Access Compliance Report

Public Rights-of-Way

Intersection ID: 52306	Main Street: IMPATIEN_DR	Cross Street: AMERIA_RD	Location: NE
ADA ID: CA5894EB9E67	Ramp Type: BlendTrans1	Initial Pass/Fail: Fail	Overall Compliance: No
		Severity Score: 8.75

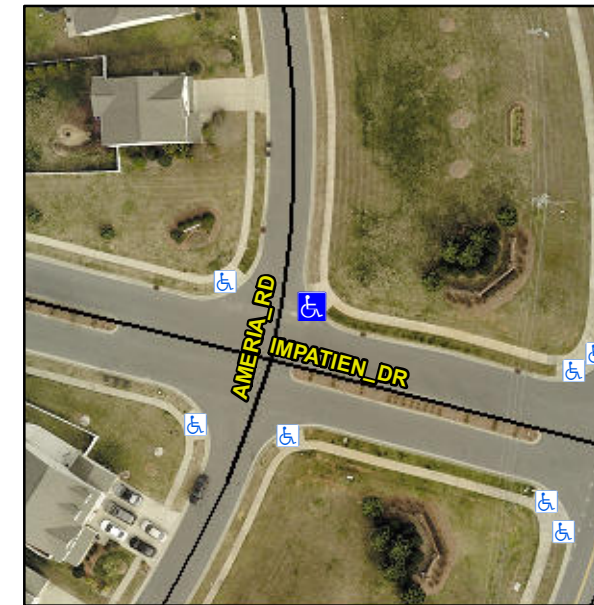
Not Found, R304.5.1

Compliance	Description	Data	Compliance	Description	Data
N/A	Ramp Length (in)	69.5	Yes	BlendTrans Slope (%)	3.8
No	Ramp Width (in)	46.0	Yes	BlendTrans XSlope (%)	0.4
N/A	Flare Type LT	N/A	N/A	Flare Type RT	N/A
N/A	Flare Slope LT (%)	N/A	N/A	Flare Slope RT (%)	N/A
N/A	Flare Traversable LT?	N/A	N/A	Flare Traversable RT?	N/A
N/A	Landing Length (in)	N/A	N/A	DWS Provided?	N/A
N/A	Landing Width (in)	N/A	N/A	DWS Contrast?	N/A
N/A	Landing Slope (%)	N/A	N/A	DWS Length (in)	N/A
N/A	Landing X Slope (%)	N/A	N/A	DWS Full Width?	N/A
N/A	Landing Curb? (Y/N)	N/A	N/A	DWS Offset (in)	N/A
N/A	Shared Landing?	N/A			
N/A	Gutter Ponding?	N/A	N/A	Gutter Slope (%)	N/A
N/A	Gutter Lip Ht (in)	N/A	N/A	Gutter X Slope (%)	N/A
N/A	Painted X Walk1?	No	N/A	Painted X Walk2?	No
	X Walk 1 Direction	To W		X Walk 2 Direction	To S
	X Walk 1 Width (in)	N/A		X Walk 2 Width (in)	N/A
	X Walk 1 Slope (%)	0.3		X Walk 2 Slope (%)	2.2
	X Walk 1 X Slope (%)	0.8		X Walk 2 X Slope (%)	2.1

N/A	Ramp inside XWalk1?	N/A	N/A	Ramp inside XWalk2?	N/A
	Road Slope (%)	0.8		Clear Space?	N/A
	Road X Slope (%)	0.3	N/A	Clear Space to XWalk (in)	N/A
N/A	Any Obstructions?	N/A	N/A	Storm Grate/Utility Hazard?	N/A
	Obstruction Type			Storm Grate/Utility Type	
		N/A			N/A
			Yes	Surface Condition? (G/P)	Good
			No	Curb Slope (%)	22.1

Remove & Replace Curb Ramp With Two New Directional Ramps or Equivalent.
